SUBDIVISION REVIEW SHEET

CASE NO.: C8-2019-0112.1A

SUBDIVISION NAME: Twilight Gardens

**CITY OF AUSTIN –DEVELOPMENT SERVICES DEPARTMENT
SUBDIVISION APPLICATION – MASTER COMMENT REPORT**

TWILIGHT GARDENS
PLAT OF A 17.991 ACRE TRACT OF LAND COMPRISED OF A
10.002 ACRE TRACT OF LAND AND A 7.989 ACRE TRACT OF LAND

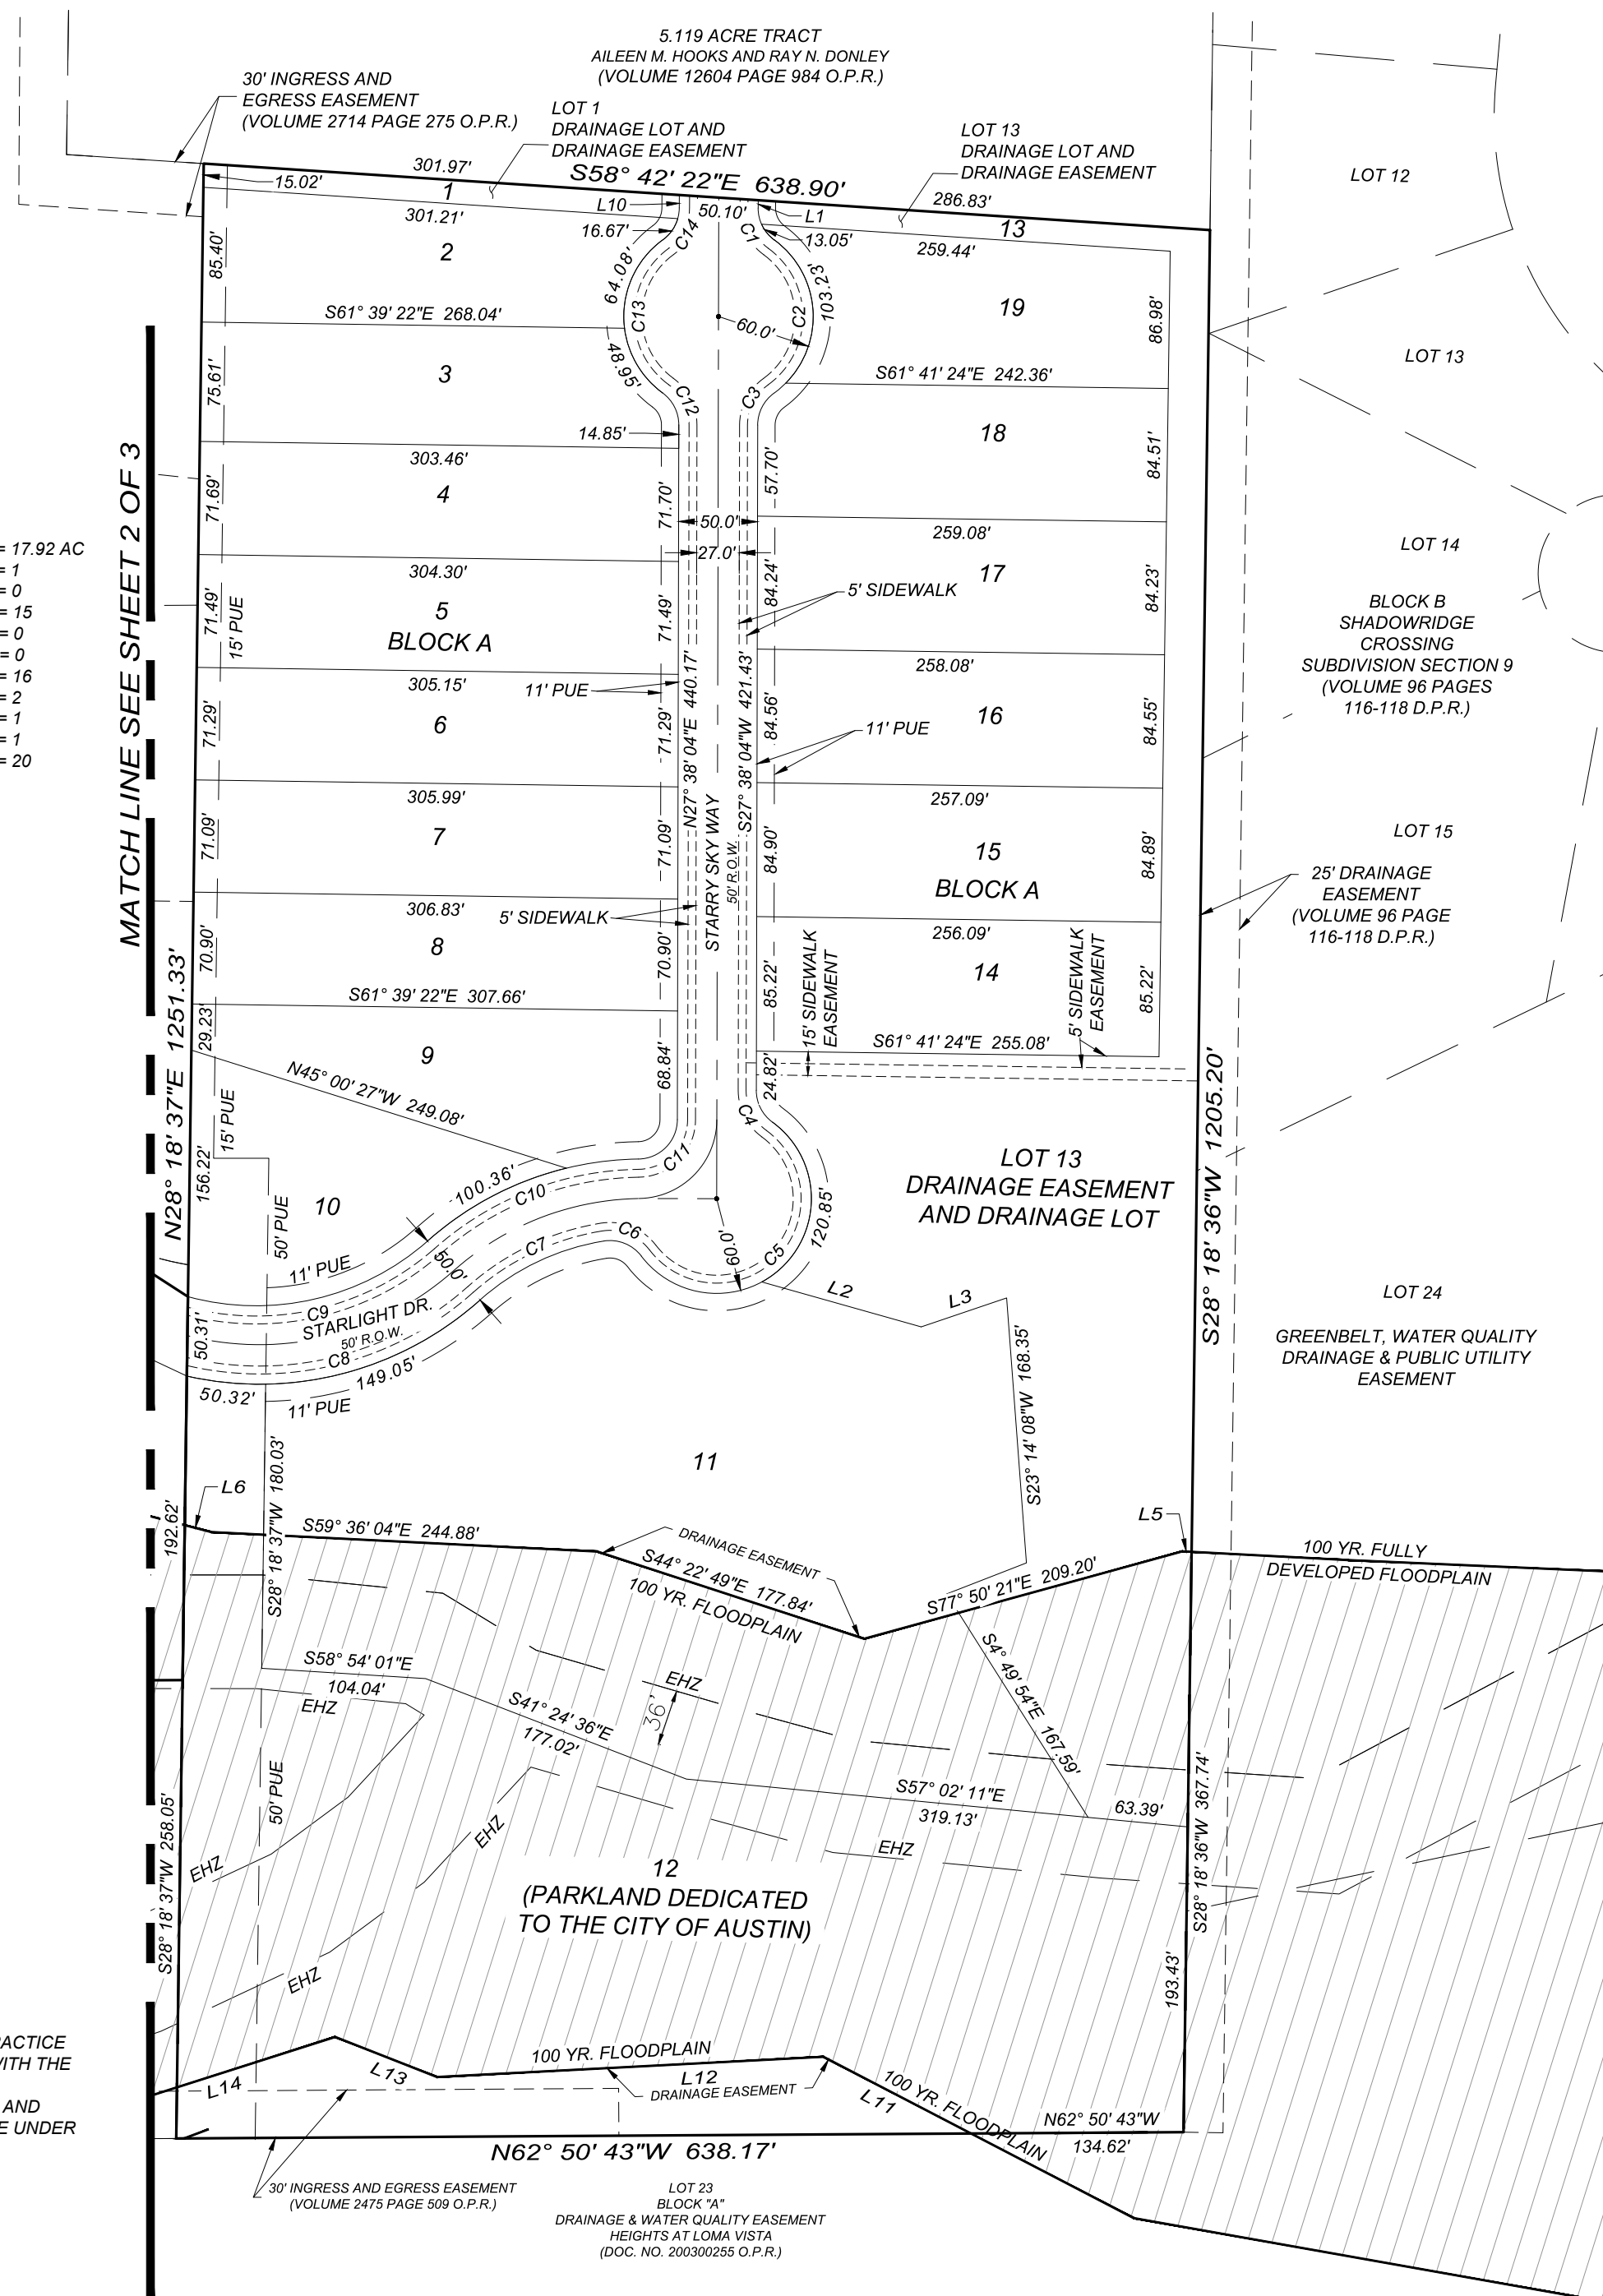
Update 1: Update the commission approval block on Sheet 3 to show as listed above. If possible, place the commission approval block on Sheet 1.

PAGE 2

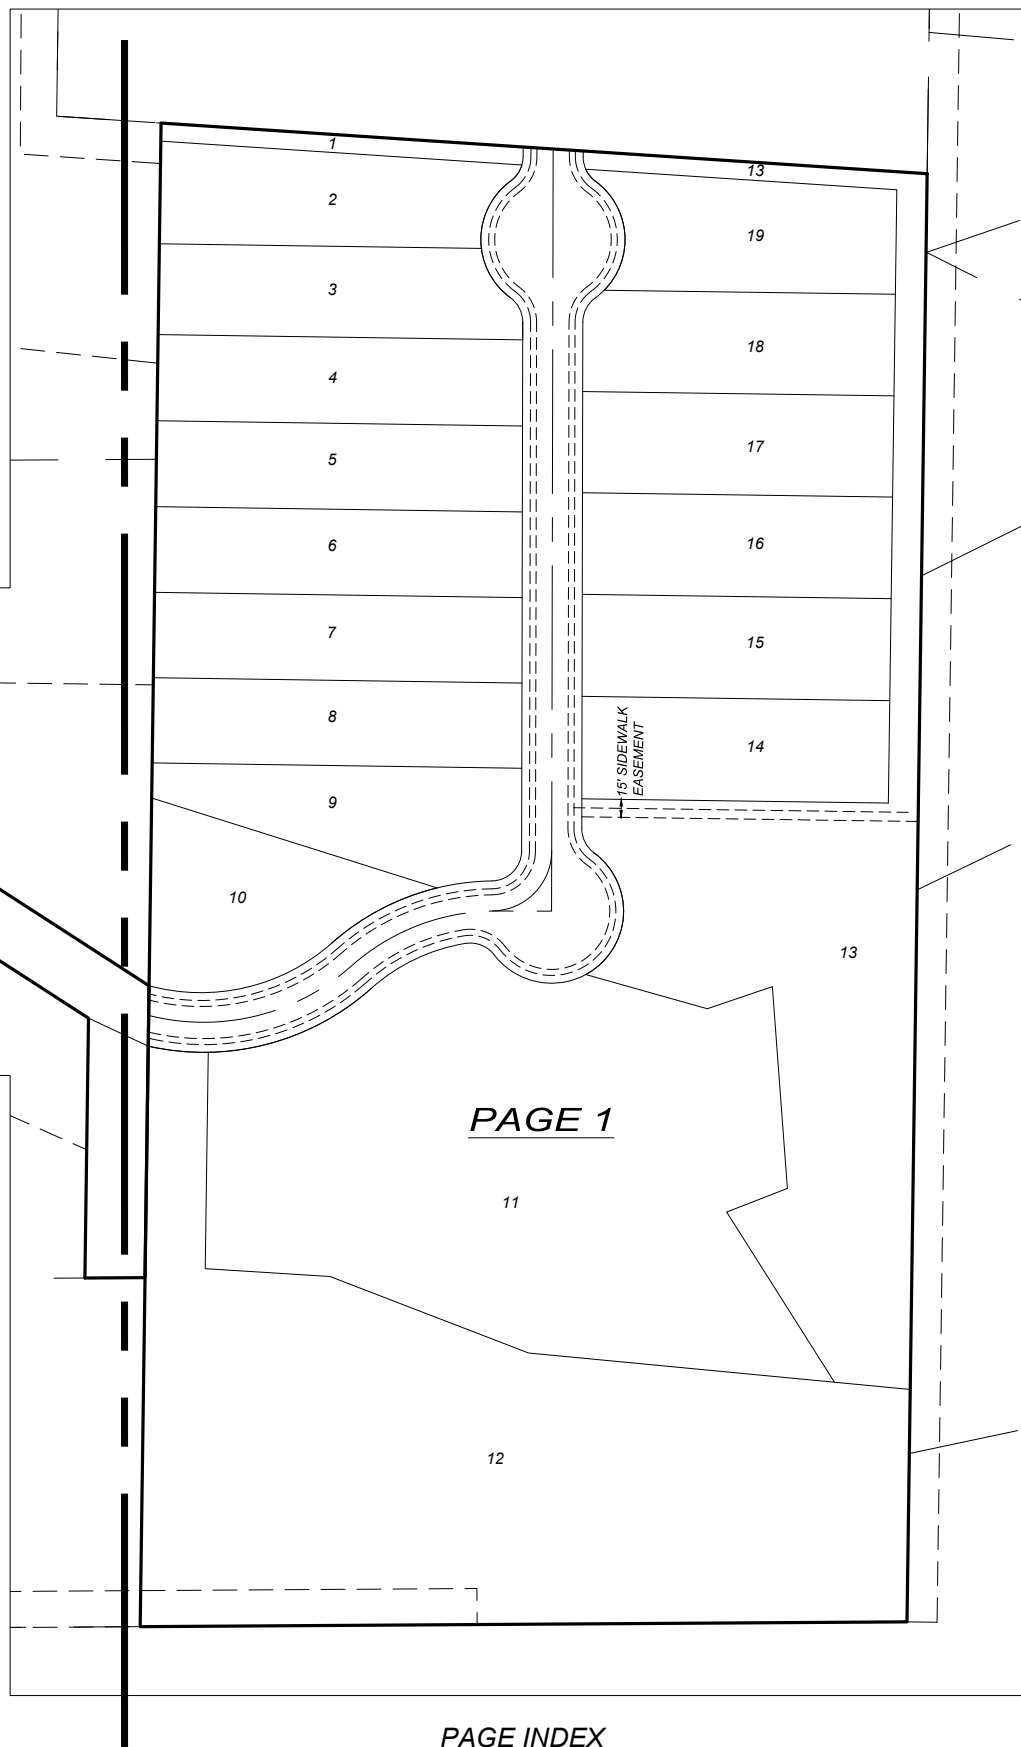
General notes: This final plat has had a project assessment for the floodplain and has been reviewed and approved by Katina Bohrer. It does not appear that the floodplain has been contained to a drainage easement on page 2 of the final plat. I reached out to confirm this with Previ Aguirre but I have not heard back yet. Please see the comments below.

FP1: The applicant is required to contain the limits of the FEMA and City of Austin Regulatory floodplain within a drainage easement per LDC 25-7-152 and/or LDC 30-4-152. Please provide documentation demonstrating this or provide requisite easement. Comment to remain open until easement has been recorded.
